AS BUILTS	
Contractor: Pearson Construction 7/23/2018	Project Inspector: Larry Gann KEMILLER ENGINEERING P.A. 117 E. Lewis, Wichita, KS 67202 (316)264-0242

WATER DISTRIBUTION SYSTEM to serve YINGLING AND 'DOC' HANGARS

1780 S. - 2010 S. AIRPORT ROAD
CITY OF WICHITA, KANSAS

Project Number
2116 PPW (183021)

C4.0
PPW TITLE

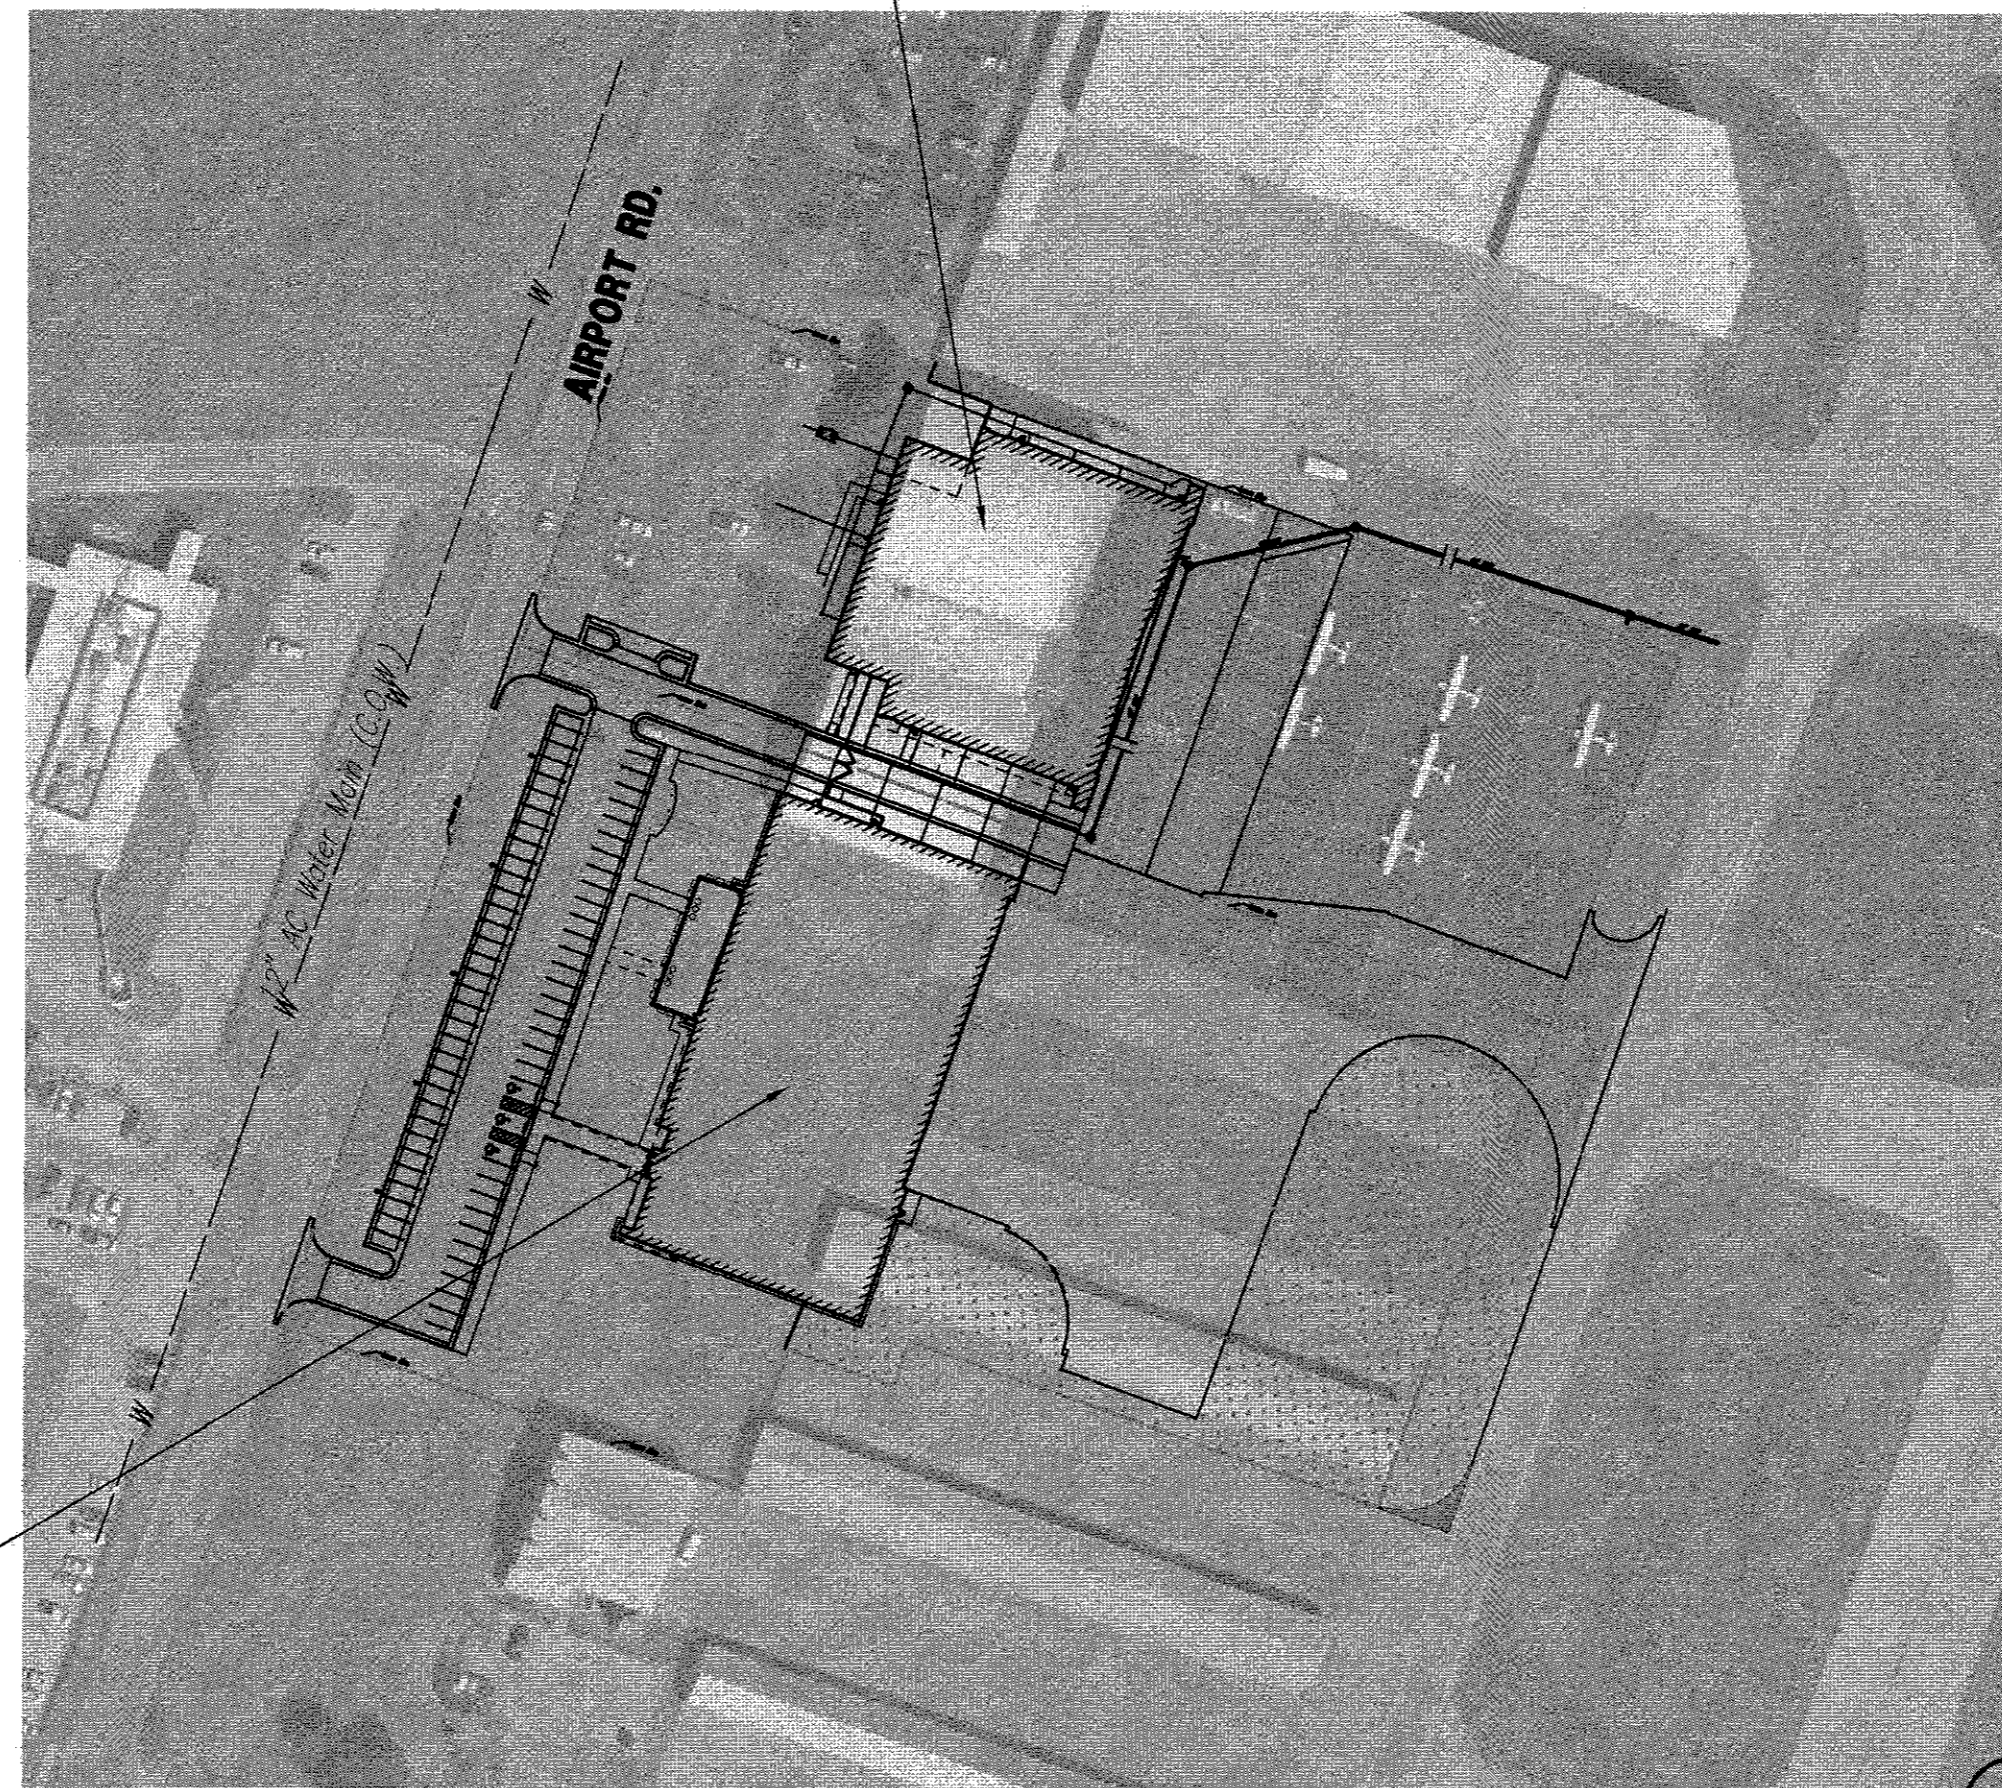
From existing fire hydrant at 1761 Airport Road from said fire hydrant 14' West & 81' North to tapping valve - also 161/2' West of West curb of Airport Road From new tapping valve East 132' to 12"x12"x6" tee for fire hydrant 4' South of tee to fire hydrant

12" McWane Ductile Vinylplex 12" C-900 North American Specialty Products
Restrained joint pipe
Sigma fittings
Pro-trace wire
Clow (storz) fire hydrant
12" Kennedy Butterfly valve
Dig tape

C4.4
 WATERLINE
 PLAN-PROFILE

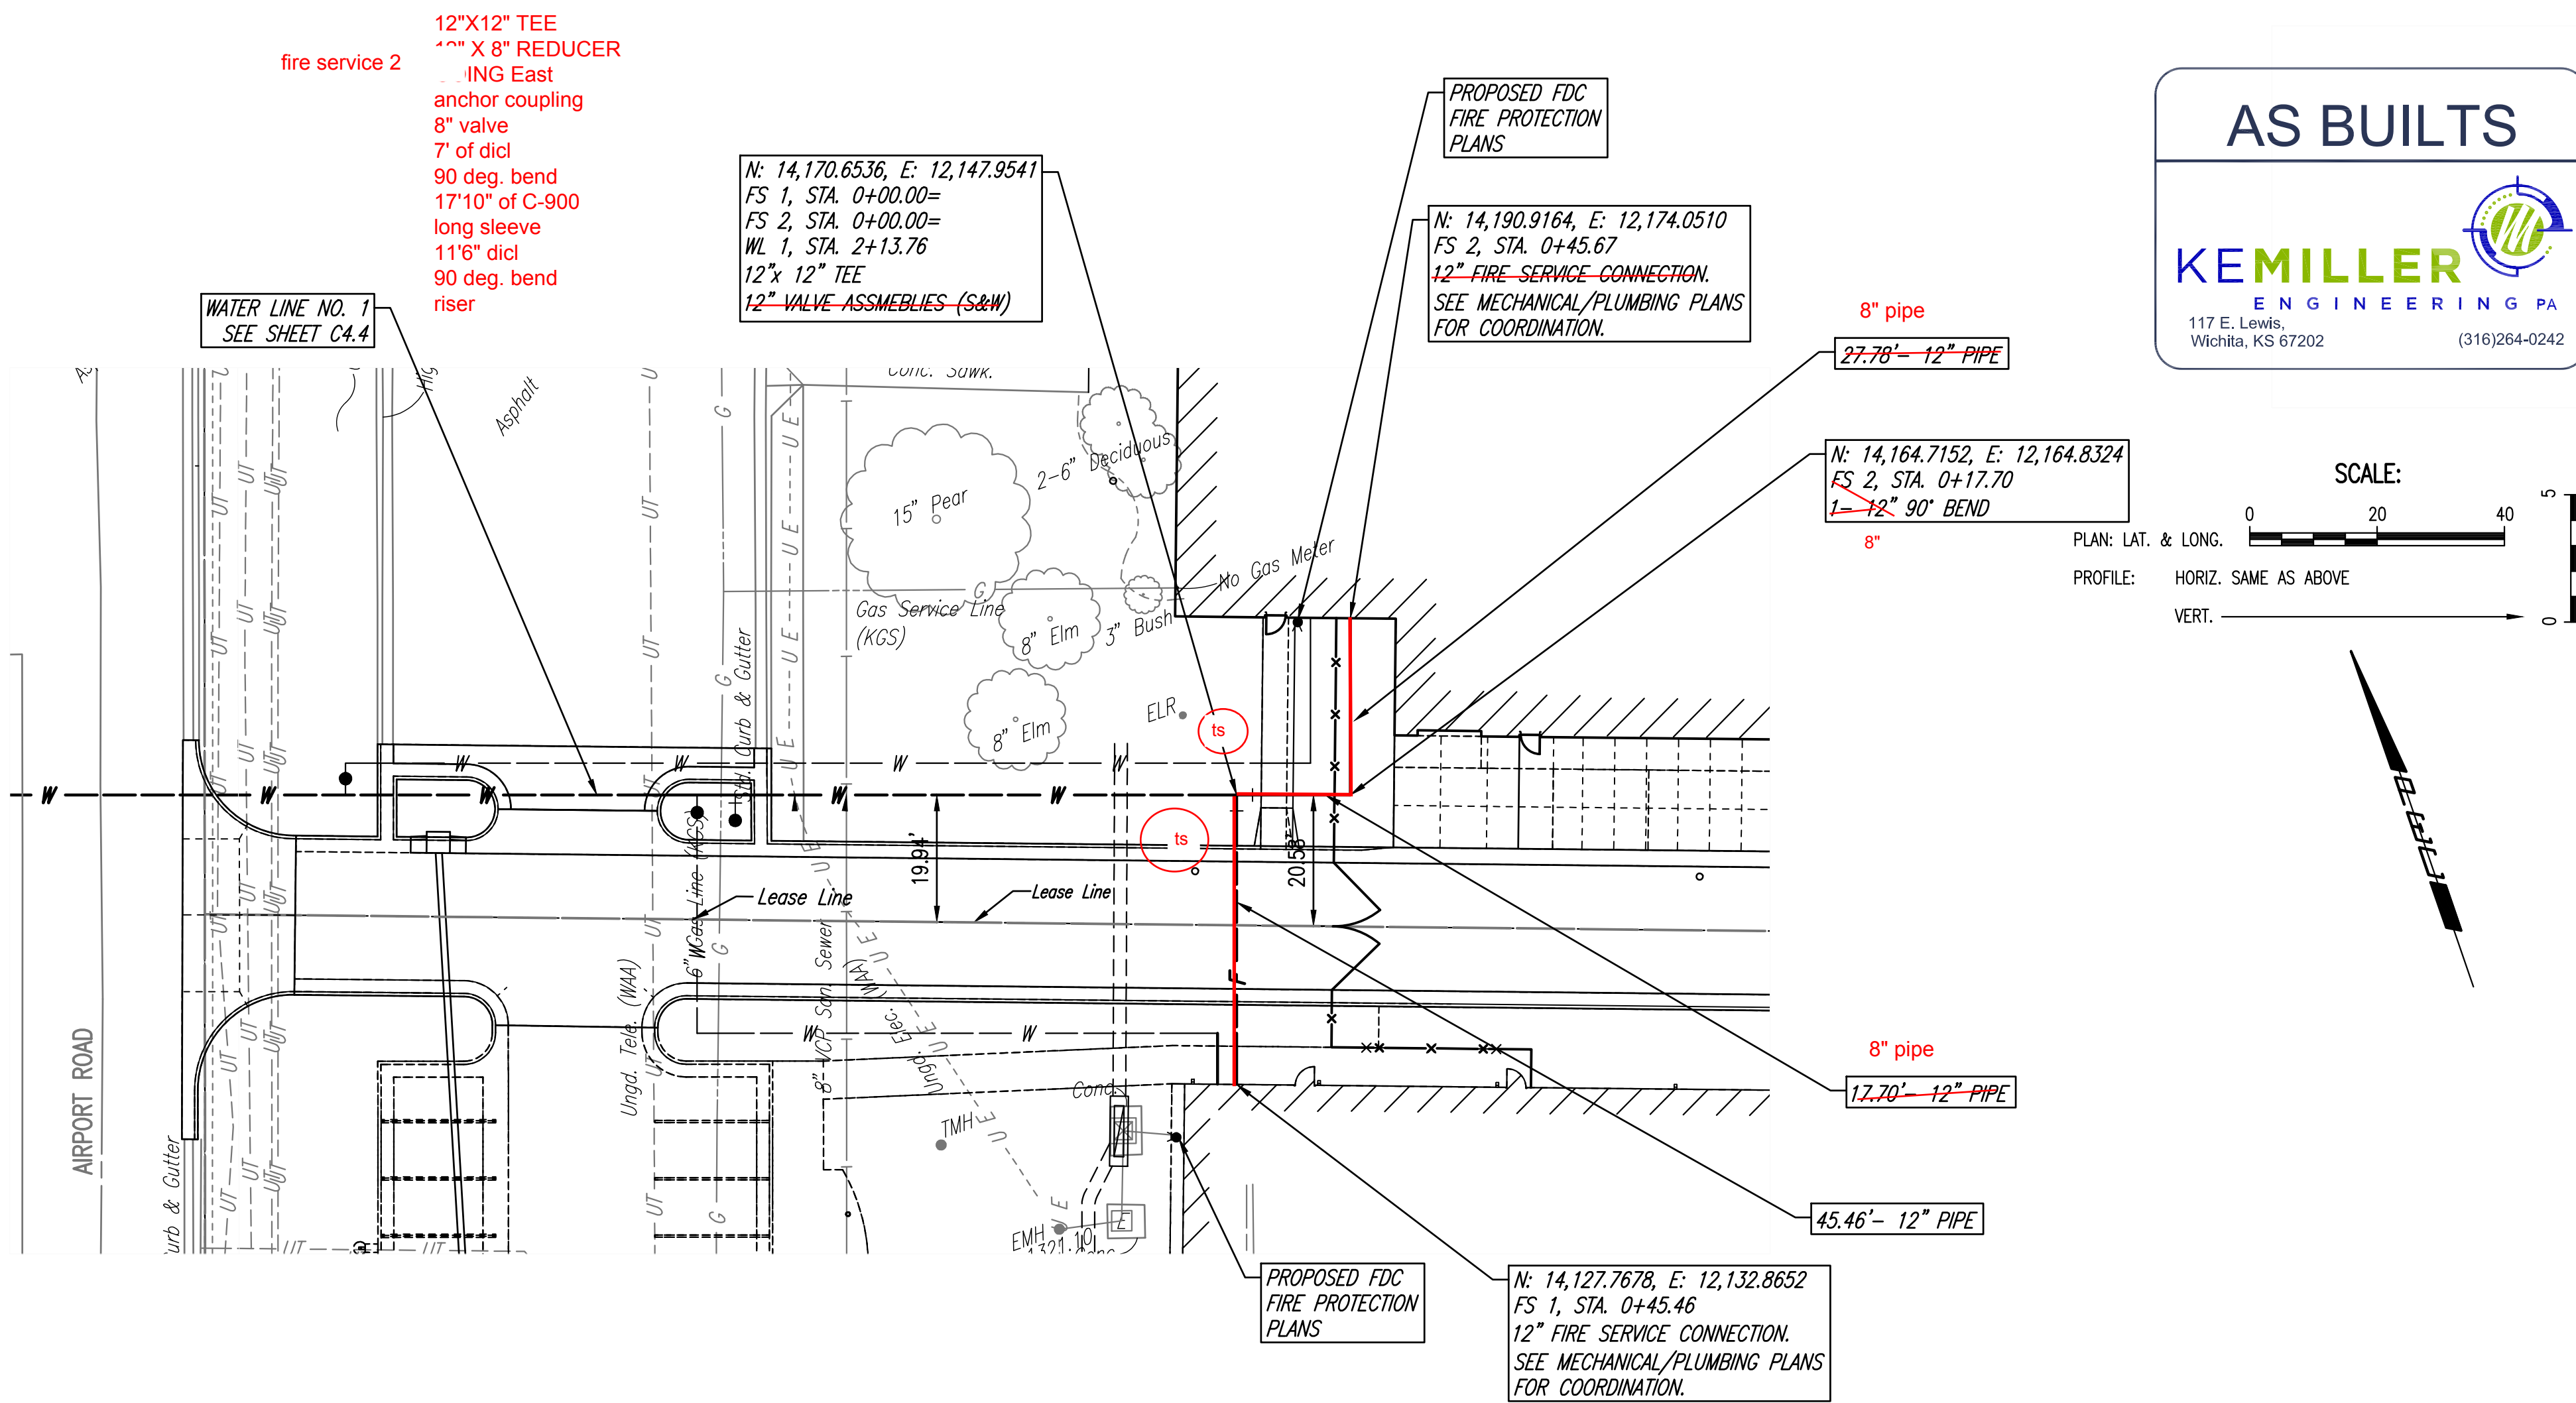
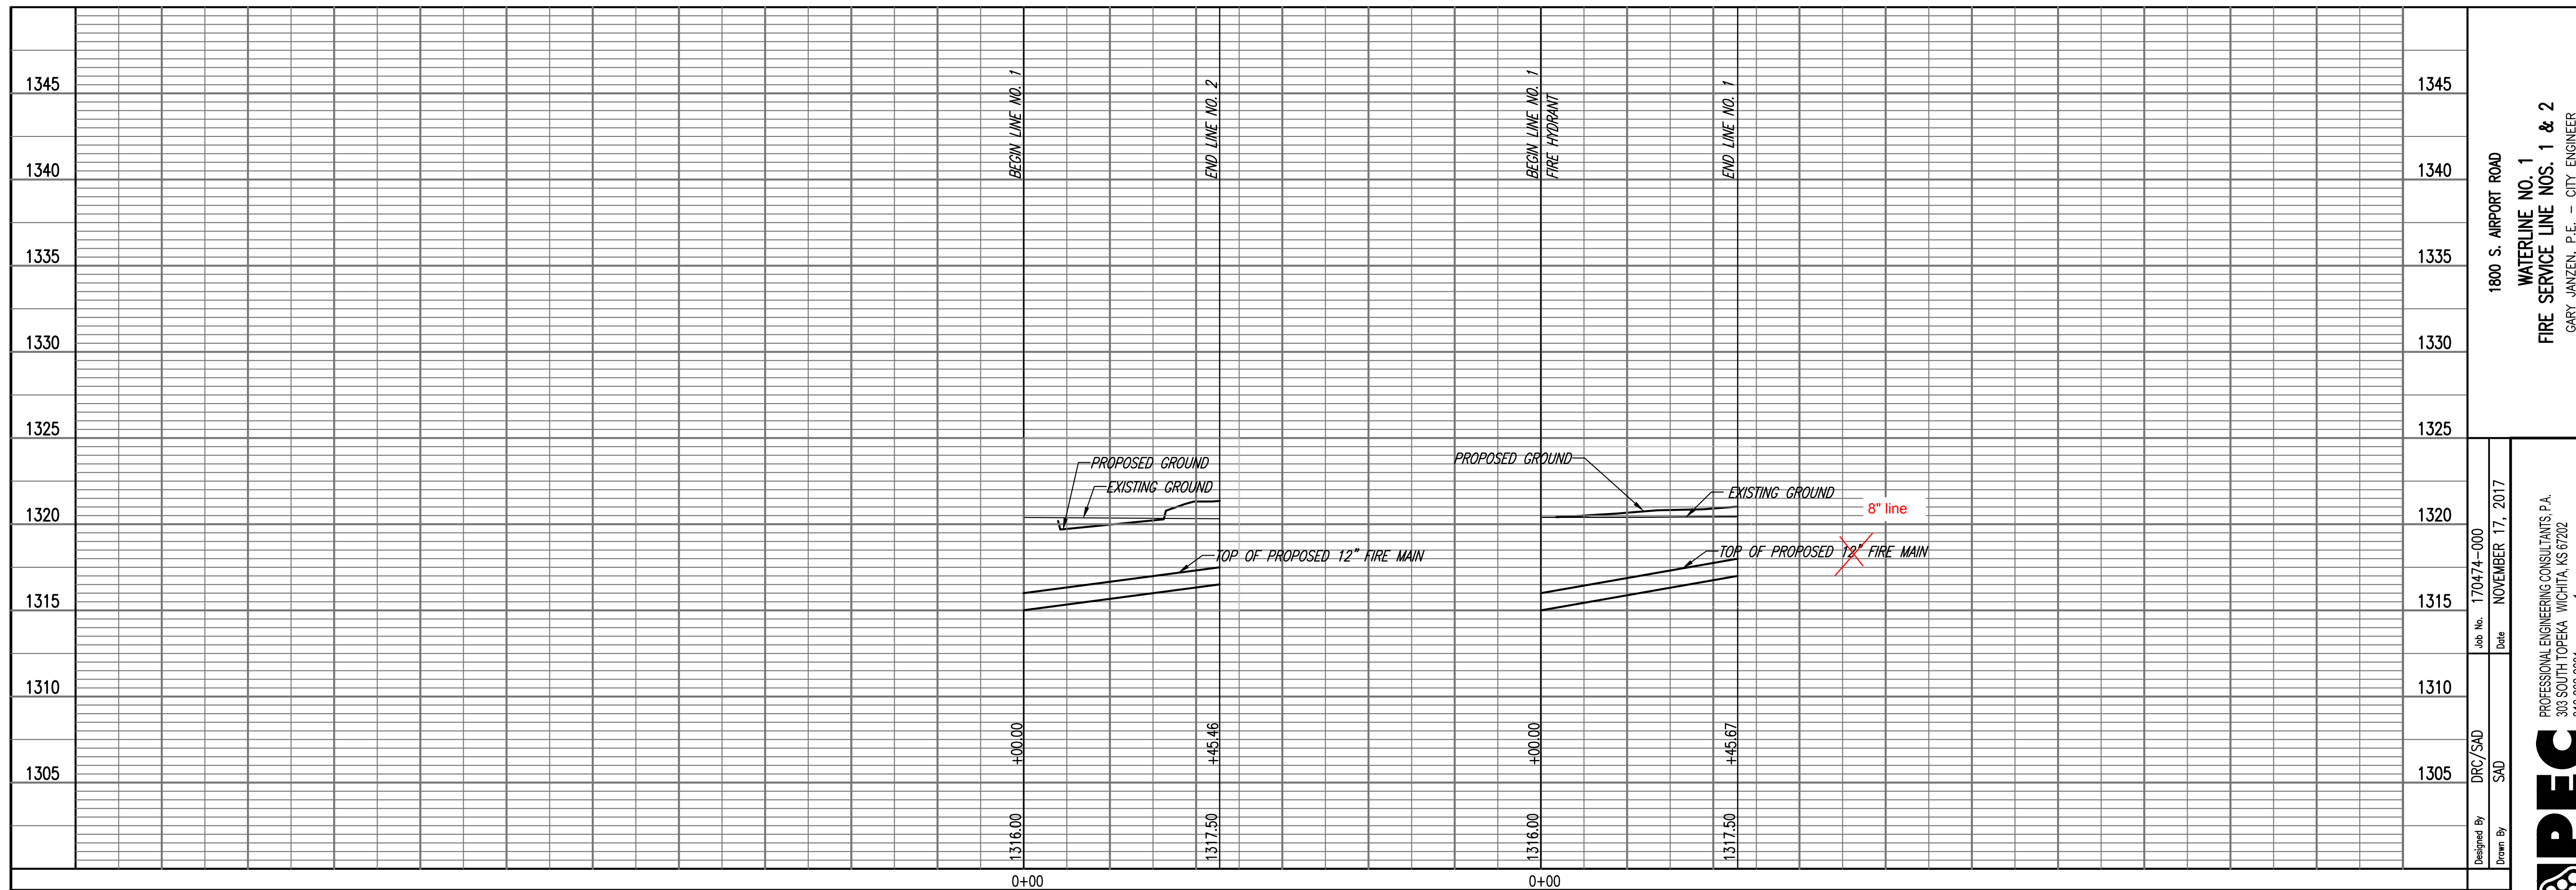
fire service 1
 SAME TEE AS
 LINE 2
 Going South
 18" diad
 12" Kennedy
 Butterfly valve
 37" of C-900
 long sleeve
 92 1/2" of diad
 90 deg. bend
 riser

fire service 2
 12"x12" TEE
 4" X 8" REDUCER
 ING East
 anchor coupling
 8" valve
 7" of diad
 90 deg. bend
 17"10" of C-900
 long sleeve
 116" diad
 90 deg. bend
 riser
